Access Compliance Report

Public Rights-of-Way

(Curb Ramps)

| Intersection ID: 15102 | Main Street: QUEENS_RD | Cross Street: E_MOREHEAD_ST | Location: SW |

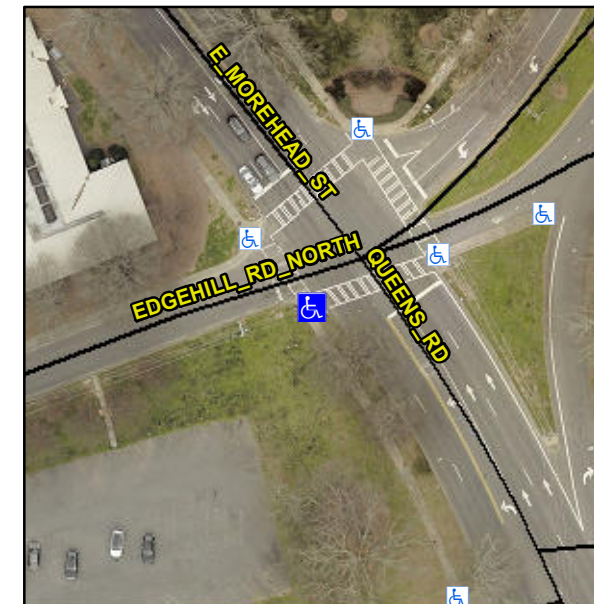
| ADA ID: 130EECA6EAA8 | Ramp Type: BlendTrans1 | Initial Pass/Fail: Fail | Overall Compliance: No |

Not Found, R304.5.1

| Compliance | Description | Data | Compliance | Description | Data |
|------------|-----------------------|-------|------------|-----------------------------|-------|
| No | Ramp Width (in) | 47.0 | Yes | BlendTrans XSlope (%) | 2.5 |

Remove & Replace Curb Ramp With Two New Directional Ramps or Equivalent.
